Office Action Summary	Application No. 10/575,258	Applicant(s) MIGLI, CARLO	
	Examiner Jeffrey O'Brien	Art Unit 3677

DETAILED ACTION

2. Claims 1-5, 7-8, 25, 33-34, and 37-40 are rejected under 35 U.S.C. 102(e) as being anticipate by Salice (US 7,497,532) herein referred to as '532.

Annotated Fig. 2

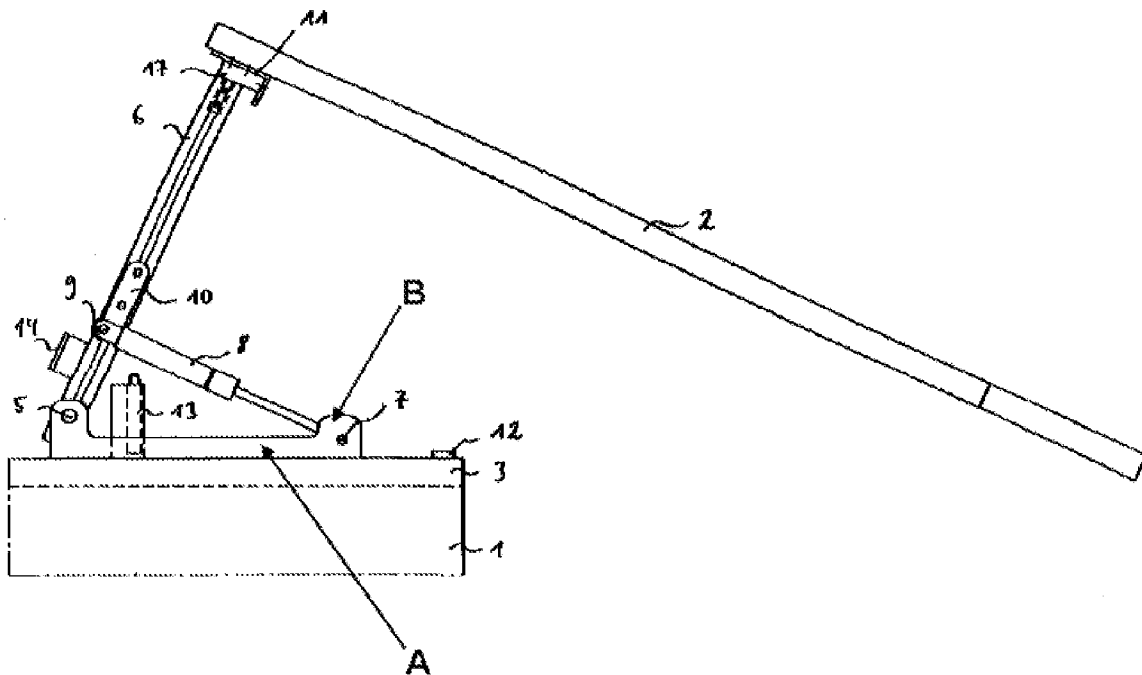
3. For Claim 1, '532 discloses a hinge assembly (Fig. 2) for the connection of a vertically opening panel (2) to an element (1) between a closing position (Fig. 1) and an opening position (Fig. 2) comprising:

a supporting base (annotated Fig. 2: A);

a lifting lever (6) operatively connected to the panel (2) and directly hinged to the supporting base (A) about a first pivoting axis (at 5) between said closing and opening positions of the panel;

a balancing device (8) hinged to the supporting base (A) about a second pivoting axis (7) and acting on the lifting lever (6) along a direction of thrust defined by a line joining the second pivoting axis and a point of application of the thrust on the lifting lever to at least partially counterbalance the weight of the panel during rotation of the lever about said first pivoting axis (as seen in Fig. 2);

wherein the second pivoting axis (7) defines with the first pivoting axis (5) a dead center plane (as seen in Figs. 1-2);

wherein the first pivoting axis (5) and said balancing device (8) are positioned above an upper surface (3) of the element (1) in the mounting position of the hinge assembly (as seen in Figs. 1-2);

wherein in said closing position (Fig. 2) of the panel the second pivoting axis (7) is interposed between the panel (2) and the first pivoting axis (5); and

wherein the direction of thrust of the balancing device during operation is never below said dead center plane (as seen in Fig. 2); and

wherein said balancing device (8) comprises an adjustment device (10) for adjusting the thrusting force exerted by the balancing device on the lifting lever.

21. For Claim 11, '711 teaches the hinge assembly according to claim 10, wherein said hollow body (20) is hinged to at least one supporting wall (22) extending laterally to the supporting base (18). Further, '532 discloses the hinge assembly hinged to a supporting wall (annotated Fig. 2: B) extending from the supporting base (A).
